SUBJECT: Macomb Municipal Airport
Macomb, Illinois
McDonough County
Illinois Project Number: MQB-5253
SBG Project Number: 3-17-SBGP-TBD
Contract No. MB037
Item No. 8A, April 24, 2026 Letting
Addendum A

NOTICE TO PROSPECTIVE BIDDERS

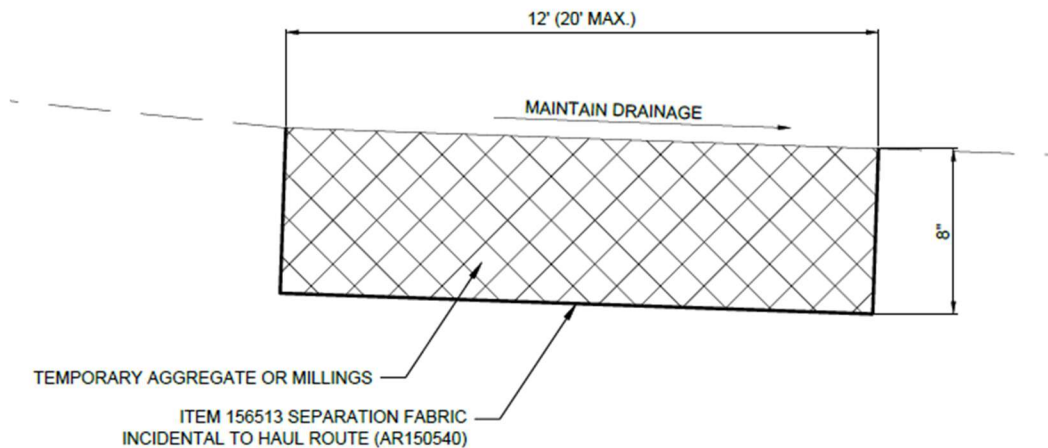
More detailed information is being provided regarding the proposed haul route.

The detail and notes below apply to the proposed haul route.

1. Haul route to be removed at project completion. Incidental restoration will be required and may include tillage of any existing farm ground due to compaction, seeding and mulching of stockpiles, and additional aggregate to correct any deficiencies due to hauling operations.
2. Resident engineer/technician will confirm haul route limits/location prior to installation. The contractor may increase width/depth of haul route at their expense if necessary. Max size of staging area is 150' x 150'.
3. All work and materials involving haul route shall be paid for under item ar150540 "haul route" – per Lump sum.
